FILE P.I. # 751420-
STP00-9252-00(007)
Fulton County
GDOT District 7 - Metro Atlanta
Johnson Ferry Road - Corridor Improvements

**DEPARTMENT OF TRANSPORTATION
STATE OF GEORGIA
PROJECT CONCEPT REPORT**

Roundabout Peer Review

Subject: RESPONSE TO ROUNDABOUT PEER REVIEW COMMENTS
Project No. STP00-9252-00(007)
P.I. No. 754120, Fulton County
COSS Project No. T-0011
Johnson Ferry Road and Glennridge Drive Connector Improvements

FIGURE
1

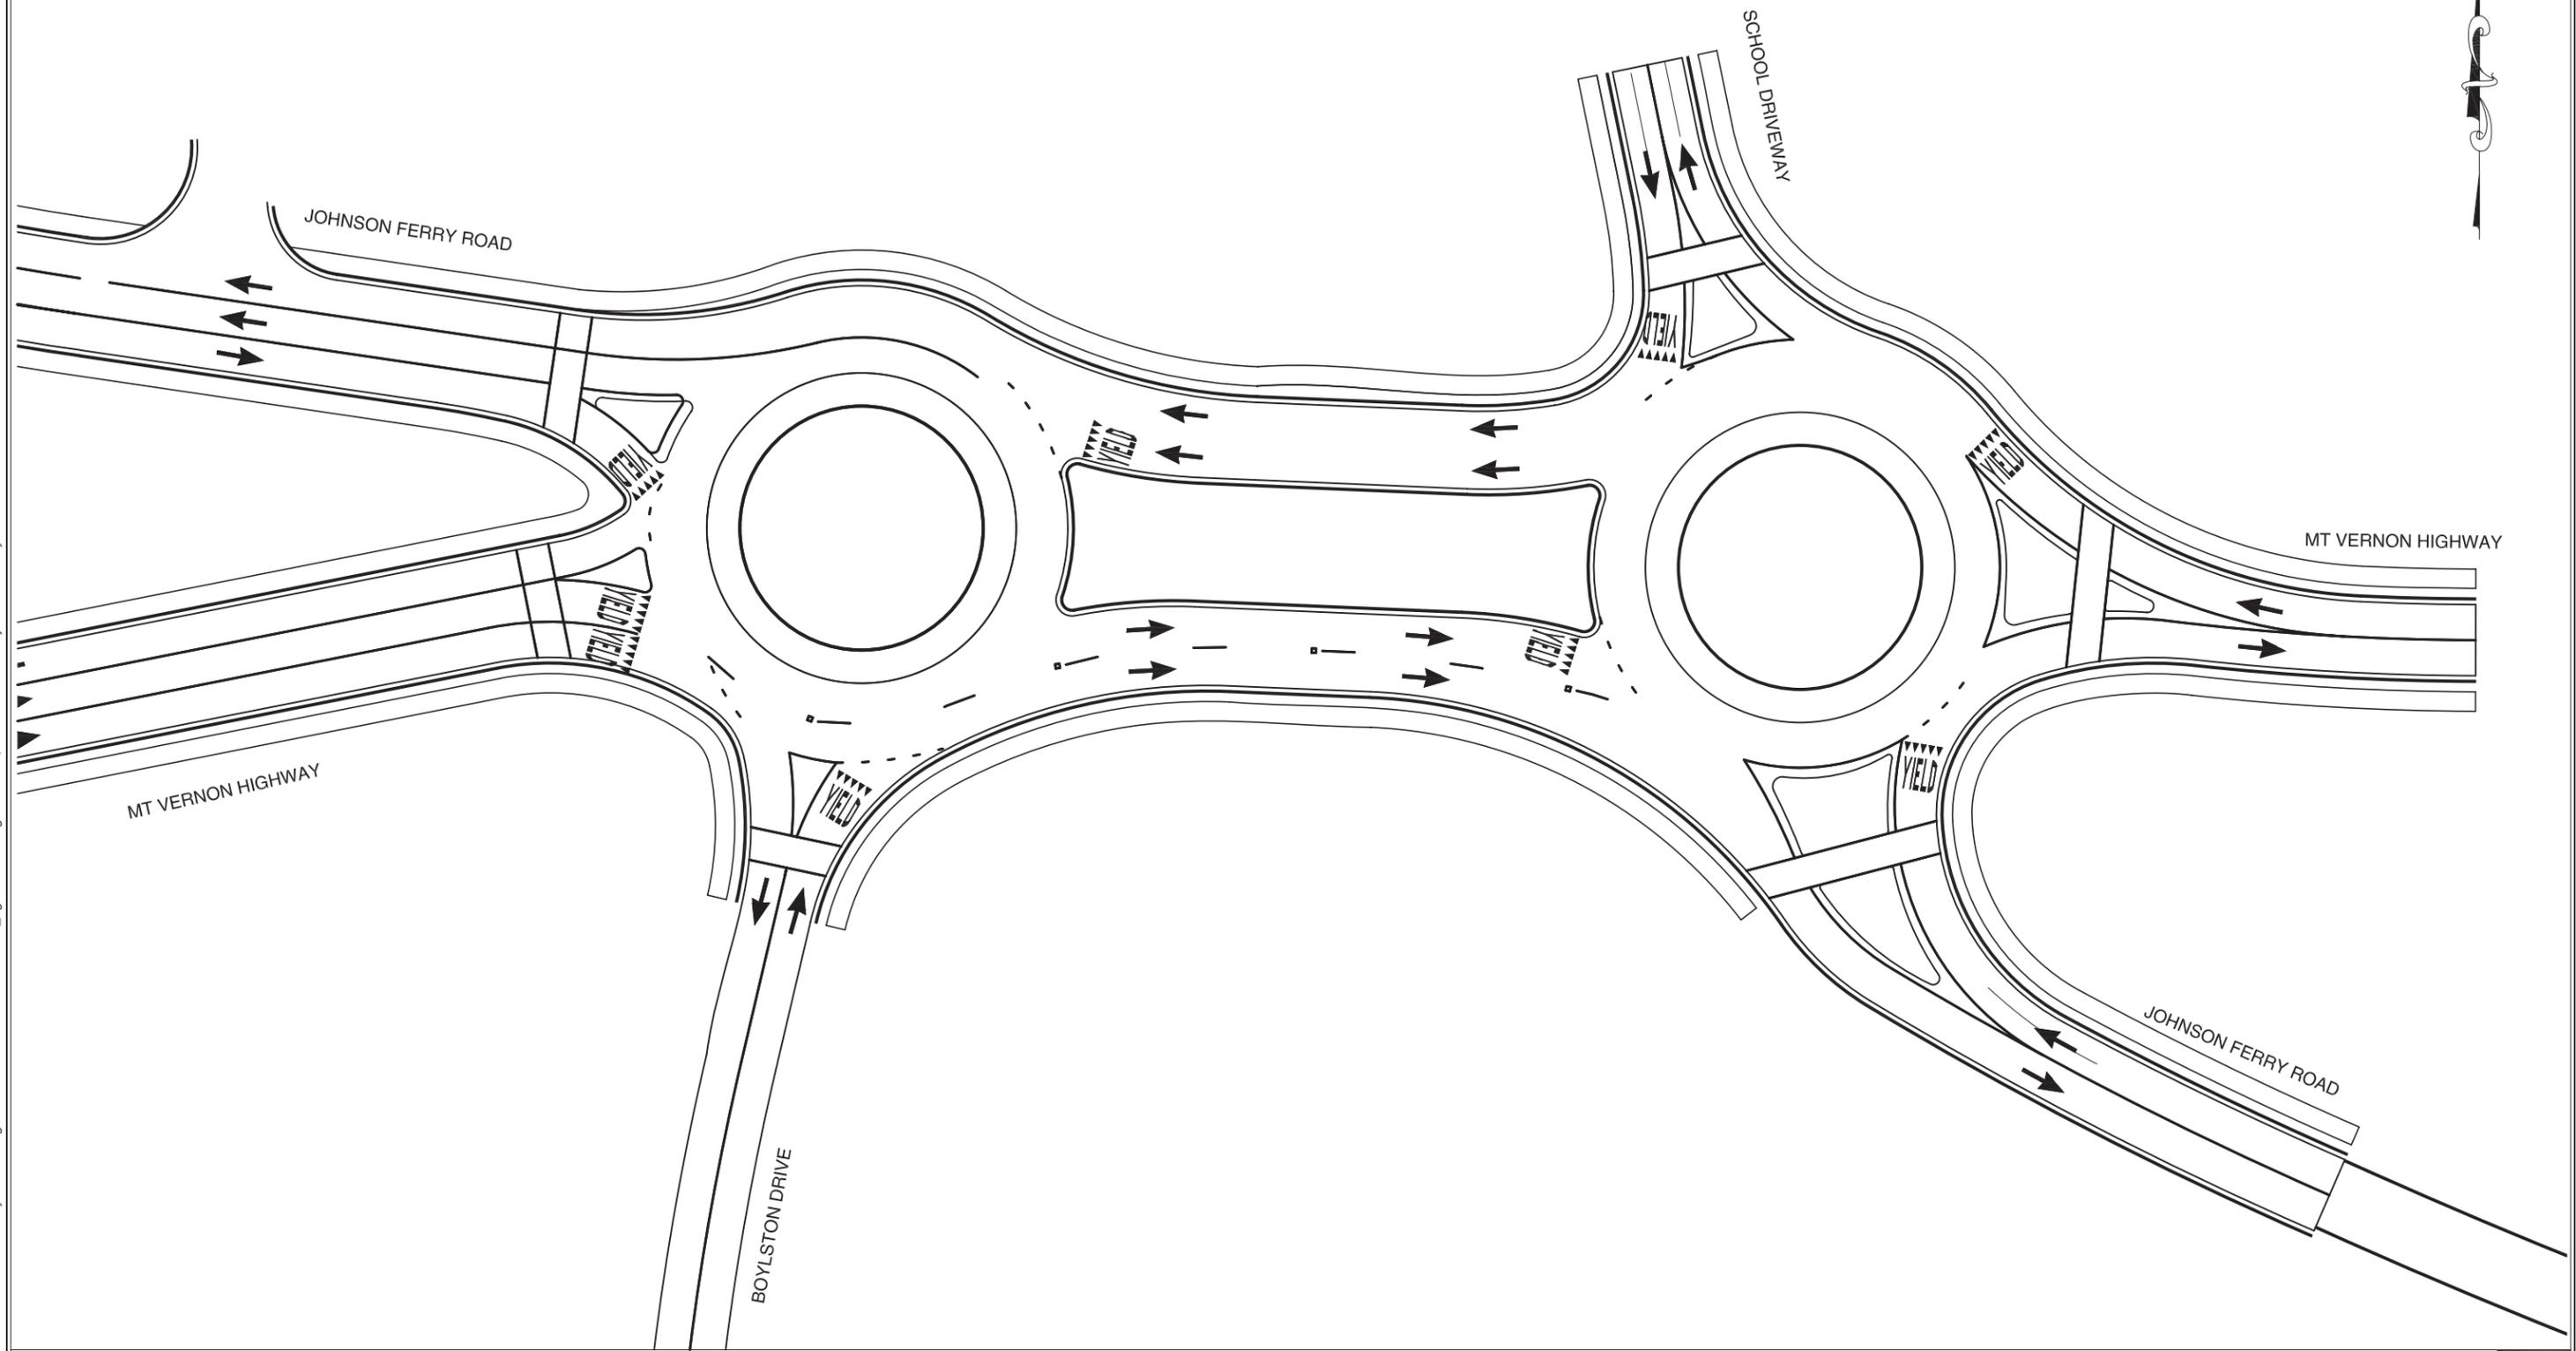
Kittelison & Associates, Inc. (KAI) reviewed conceptual roundabout designs for the intersections of Johnson Ferry Road/Mt Vernon Highway-Boylston Drive and Johnson Ferry Road/Mt Vernon Highway in Sandy Springs, Georgia. The designs were developed by Jacobs Engineering Group and were received by KAI on October 4, 2011. The roundabout designs are illustrated in Figure 1.

At the eastern roundabout, the westbound Mt. Vernon Highway approach is forecast to operate with a volume-to-capacity ratio greater than 1.0 during the 2034 p.m. peak hour. Table 2 provides the HCM 2010 analysis results for the eastern roundabout lane configurations illustrated in Figure 1.

Modifying the design to provide two westbound entry lanes at the eastern roundabout is expected to provide sufficient capacity through the 2034 design year, as shown in Table 3. The addition of a second entry lane also provides improved lane continuity with the rest of the roundabout system since the design already has two receiving lanes within the circulatory roadway. However, in order to fit the second westbound entry lane into the design, the exit lane on the same Mt Vernon Highway approach may need to be shifted further south. This is expected to further impact the accommodation of the design vehicle to make the northbound right-turn and may result in additional right-of-way impacts. If the single-lane westbound entry remains (additional right-of-way impacts are not feasible or if the City is willing to accept the delay and queuing during the PM peak hour) then additional modifications to the westbound entry are still recommended to improve yielding of entering vehicles and improve speed control as outlined in the geometric design discussion.

FIGURE 2

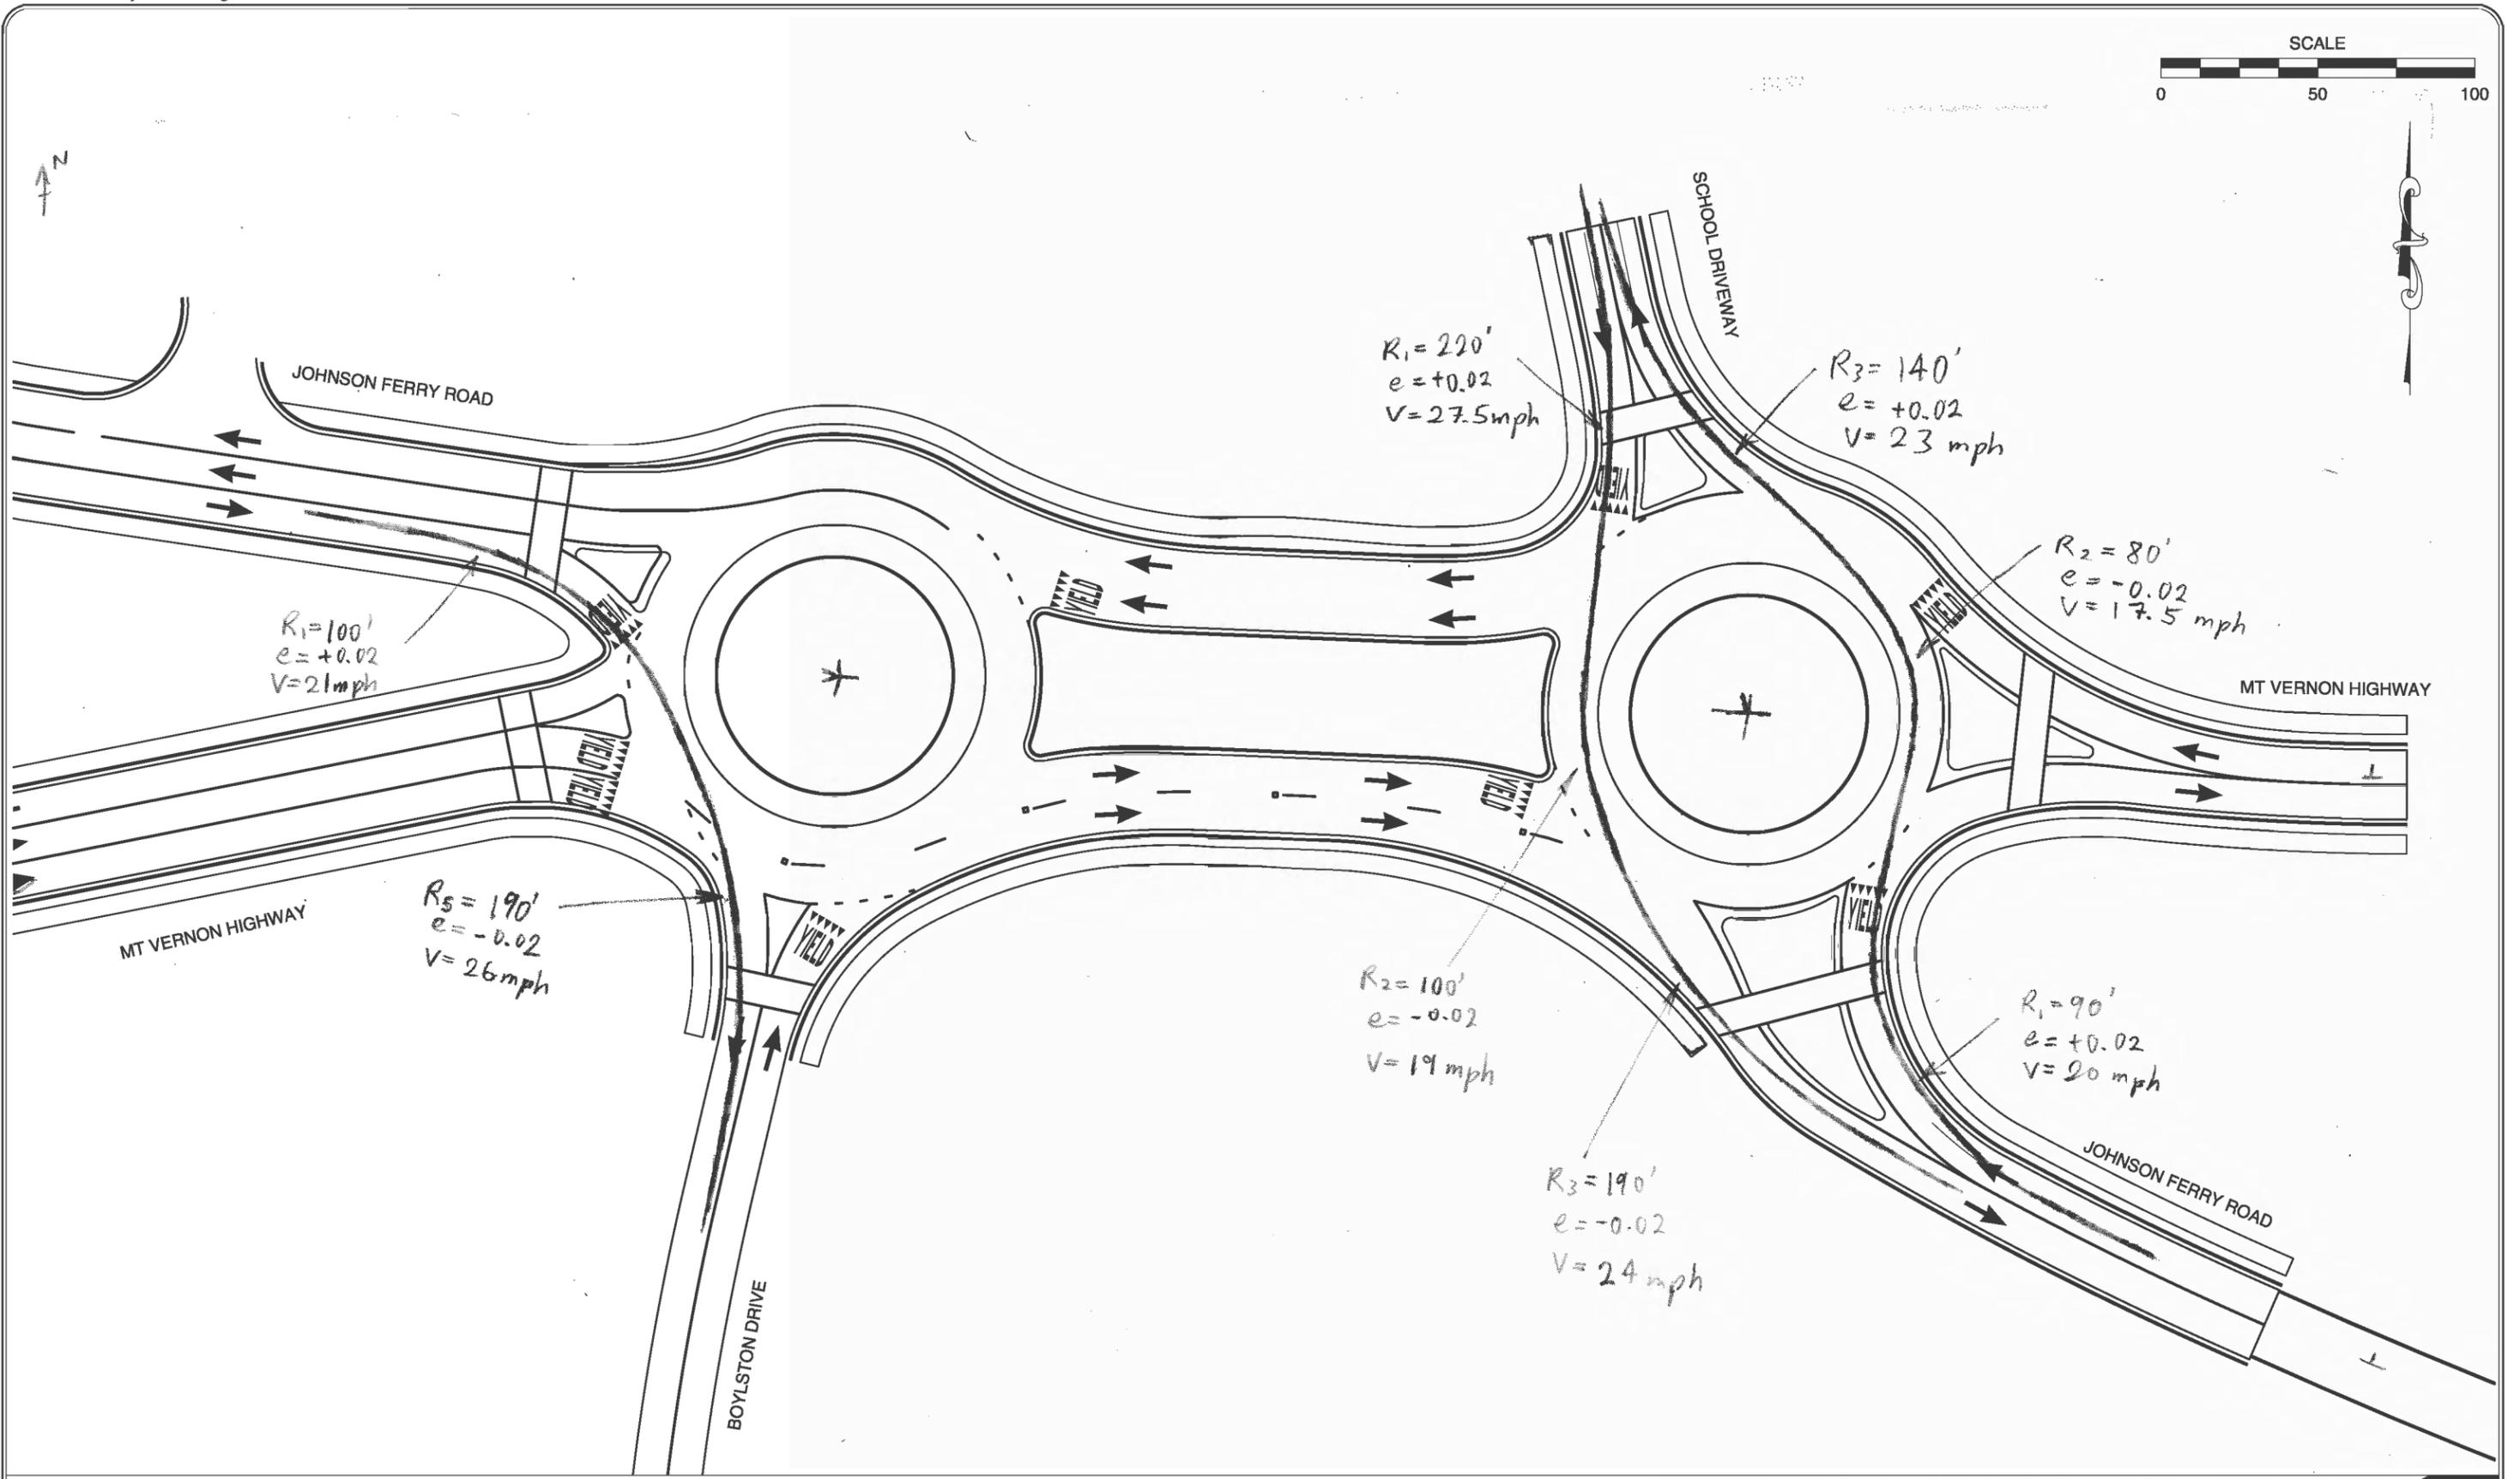
- The eastbound Mt. Vernon Highway entry at the western roundabout meets the recommendation for a maximum entry speed of 30 mph for a two-lane approach. However, modifications to the eastbound Mt. Vernon Highway entrance at the western roundabout to address other design principles (including natural vehicle paths and heavy vehicles) may further reduce the speed control on this approach. A combination of modifications, including potential adjustments to the approach alignment, roundabout size, or roundabout position may be needed.

- The westbound approach (single-lane entry) of the eastern roundabout is estimated to allow entering speeds of over 25 mph, including 31 mph for right-turning vehicles. Once a driver has entered the roundabout, there is then nearly a straight path that can be navigated between the eastern roundabout and the westbound exit onto Johnson Ferry Road at the western roundabout. This may result in higher than desired speeds through the series of roundabouts. Modification to a two-lane entry will further impact the potential speed control of the westbound entry.

- The southbound entry at the eastern roundabout does not provide the desirable deflection to achieve speed control, although the approach originates in a parking lot and thus is not as likely to generate the maximum entry speed.
